# Memo

Date: March 2017

Re: Site visit on 13 March 2017

Figure 2-1 Bathymetric map from BWDB cross sectional data of the Lower Bhadra River

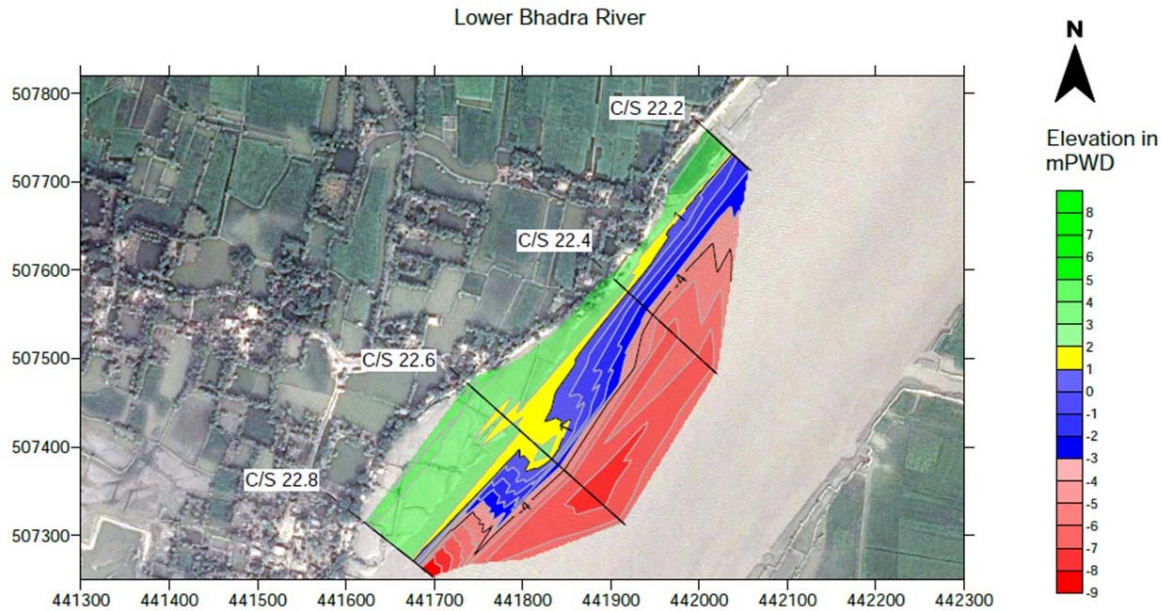
We recommend to compare both data sets and show the result in a differential map.

Figure 3-7 Eroding river upstream of the breached embankment (looking downstream)

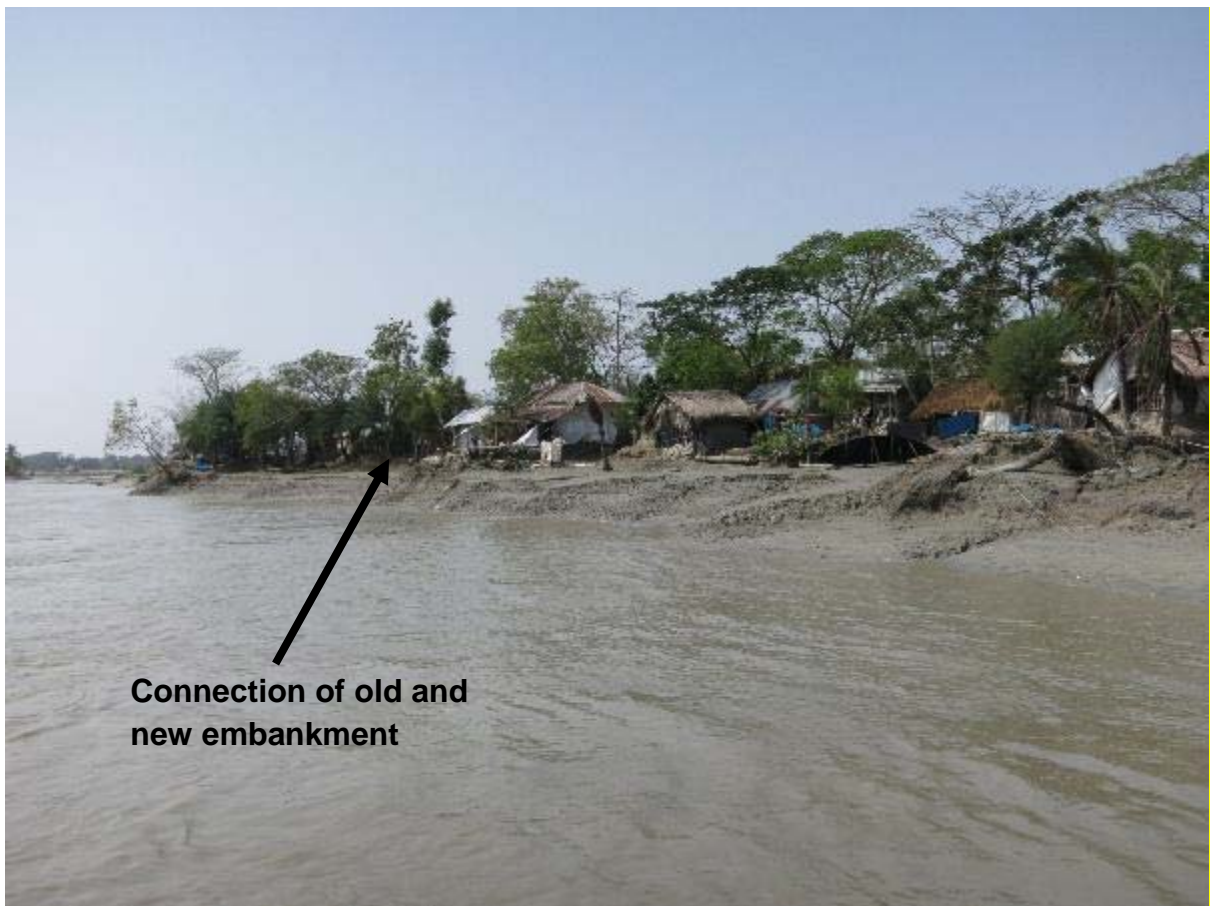
While the new embankment has some 100m setback distance to the river, the upstream connection with the old embankment is quite close to the eroding bank and situated in a densely populated area (Figure 3-7 and Figure 3-8). This location, together with the poor workmanship of the existing embankment, further aggravated by unfinished sections, results in a high risk of a renewed embankment breach during the 2017 flood season, either due to erosion, piping, or overtopping.

Figure 3-10 Estimated location and length of emergency works (image from Google Earth, November 15<sup>th</sup>, 2016)

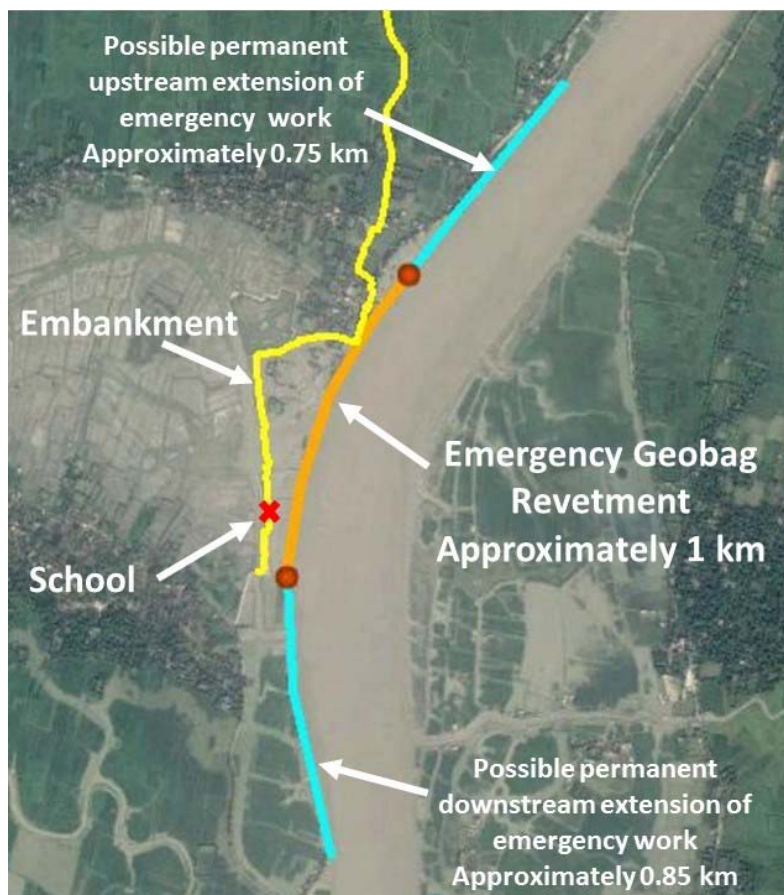
A tentative rough estimate, assuming a river depth of around 15m with 35m underwater slope length (1V:2H), results in the need of 35 250kg bags per linear meter. This translates into 35,000 bags per km, which at cost of 6 USD per bag, requires 210,000 USD per kilometer. The estimated length, taken during the site visit is around 1 km, shown in Figure 3-10.

The overall situation indicates the need for emergency riverbank protection, to control the riverbank. An easy solution is to provide a sufficiently large amount of sand-filled geotextile bags along the bank. These bags, once undercut from erosion slide down the underwater slope and protect the slope against further erosion, as the sand-fill acts as filter against the fine clayey and silty subsoils. Importantly, this type of emergency design has limitations, which need to be further investigated:

- (i) The underwater slopes of the eroding banks need to be studied, to assure that the launching process can take place – commonly slopes of around 1V:2H are attained after launching, but could be steeper in case of clay banks, even up to 1V:1H.
- (ii) The scour depth needs to be fixed, to correctly calculate the required number of bags.
